City of Litchfield

PLANNING COMMISSION

AGENDA PACKET

Monday, May 12, 2025

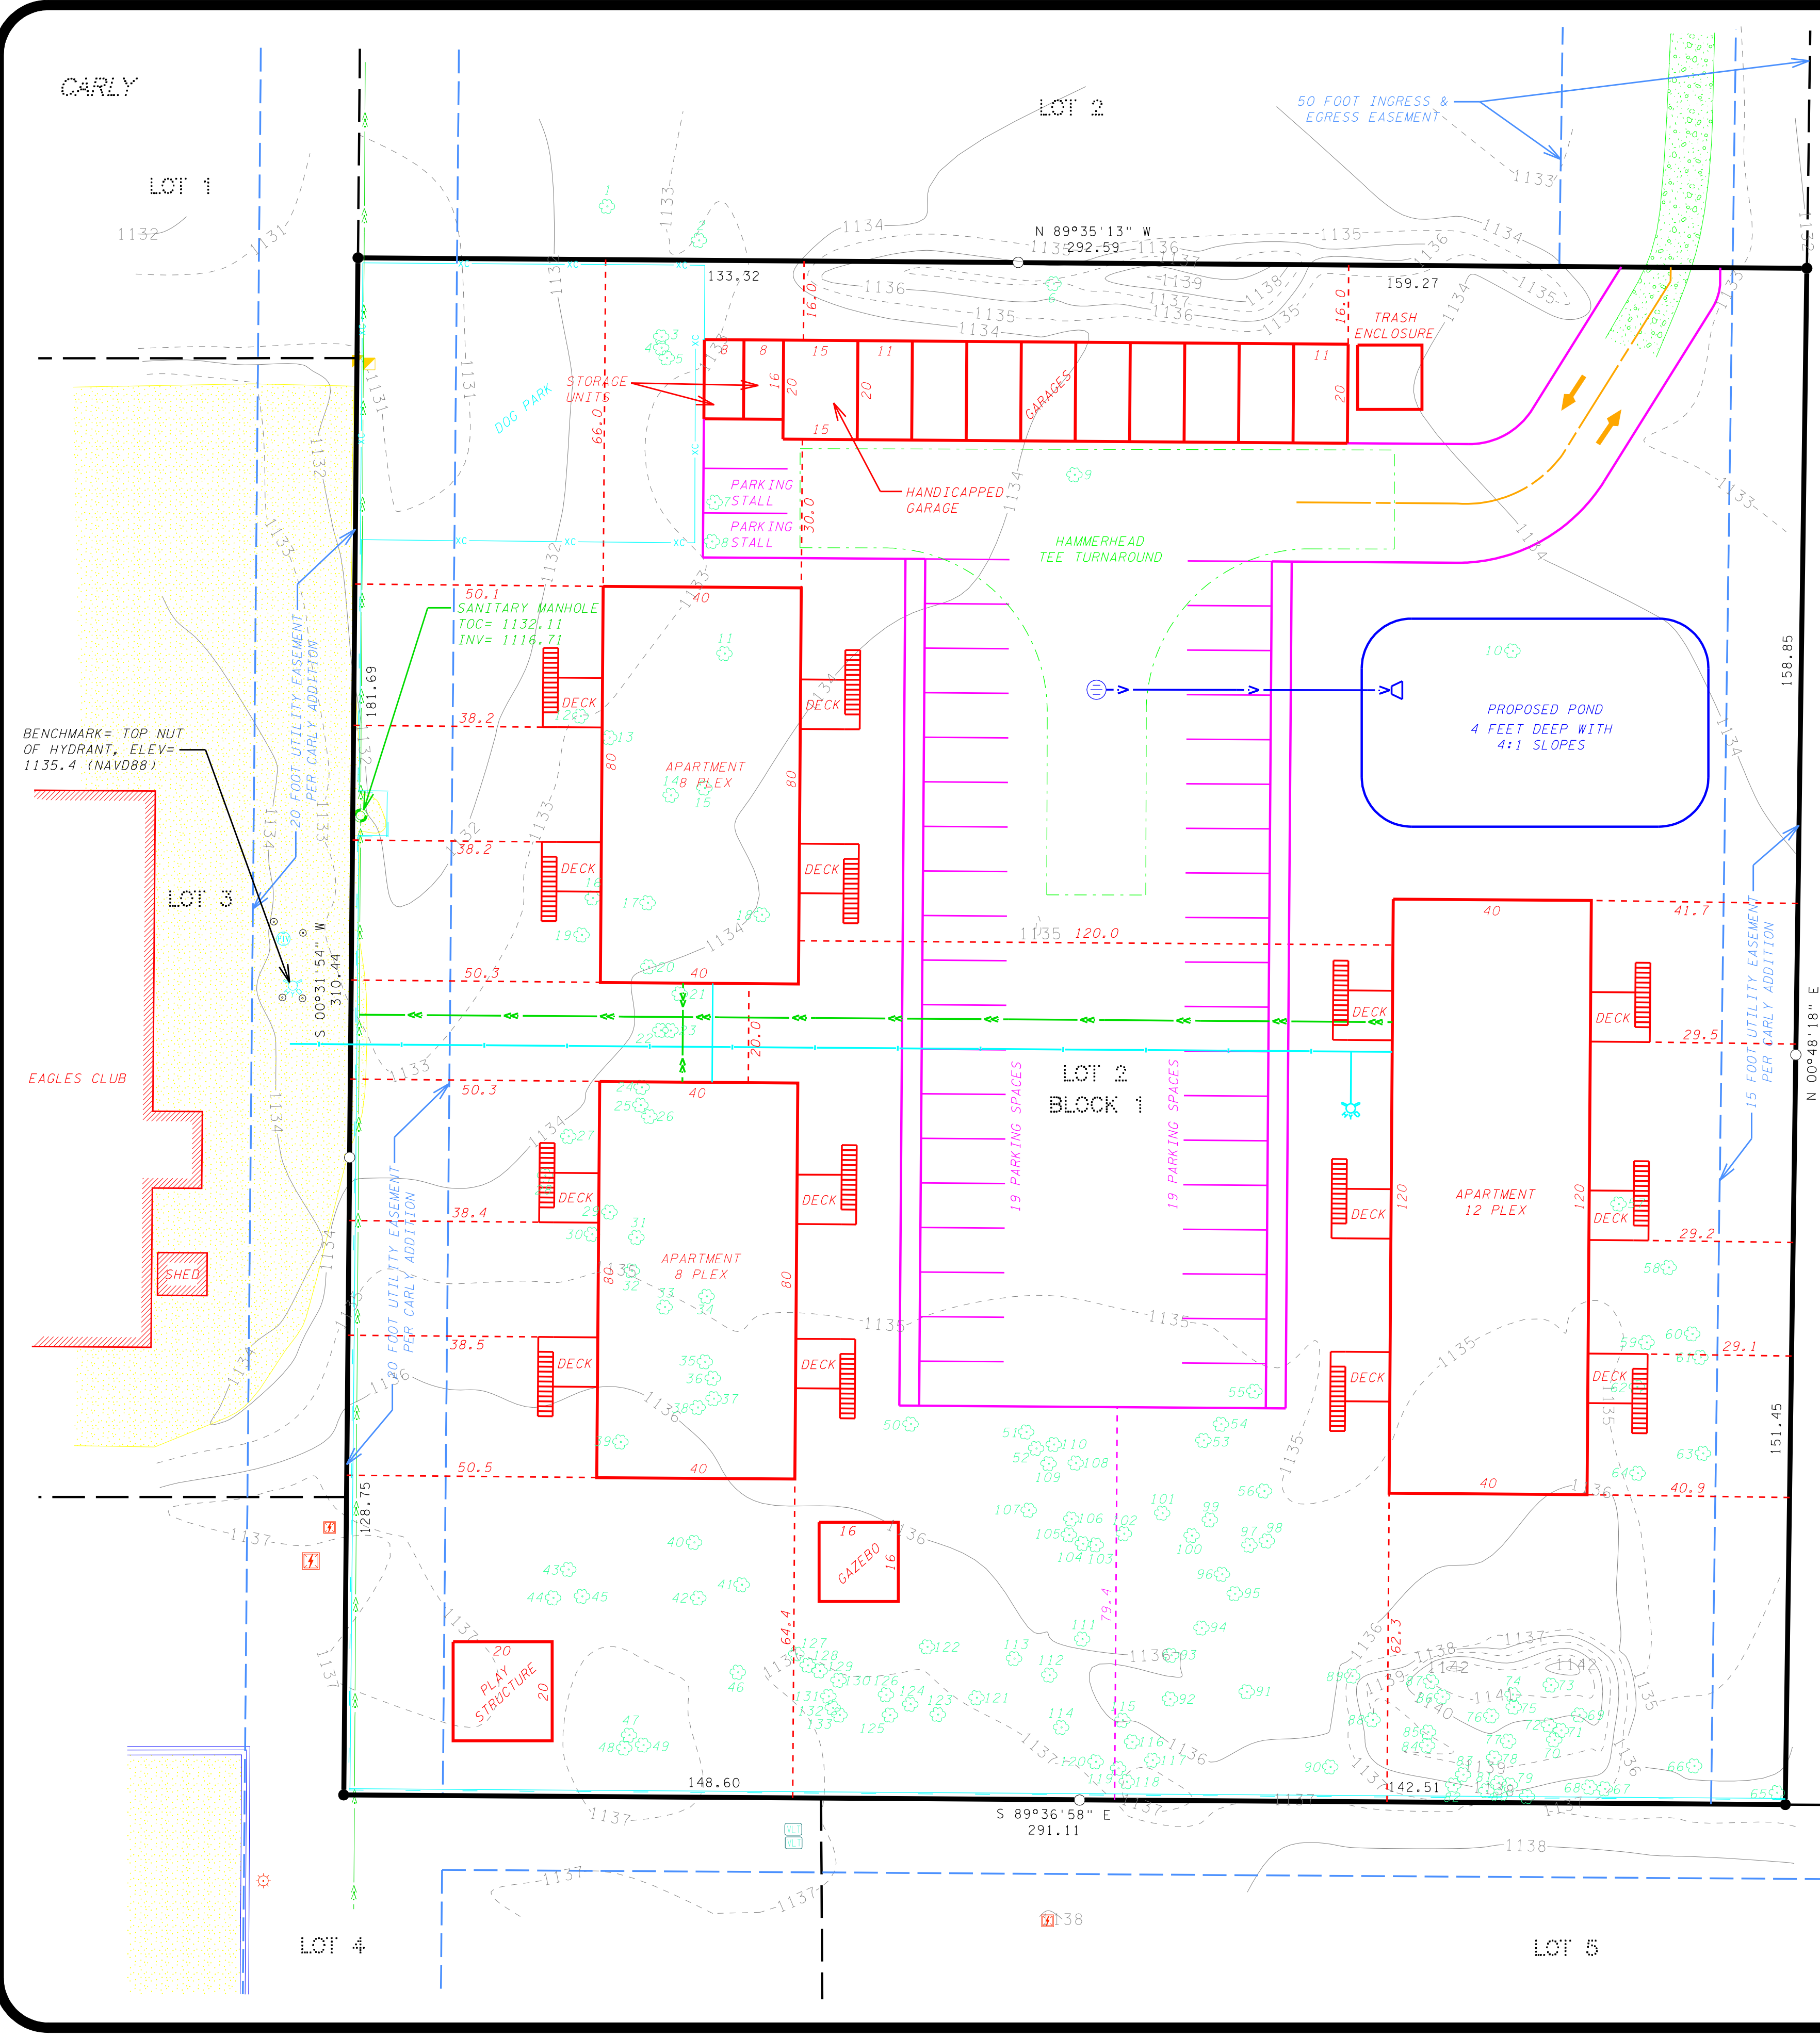
There are two additional surface parking spaces shown on the plan, to the south of the two garage storage units and to the north of the 8-unit building. To use these spaces, a vehicle would need to back up over 40 feet. This is not an acceptable design, thus these spaces must be removed from the site plan.

5. The final construction plans shall include details of the proposed sewer and water connections to the city's mainlines.
6. The parking stalls north of the westerly building do not allow for normal vehicle maneuvers leaving the parking stall.
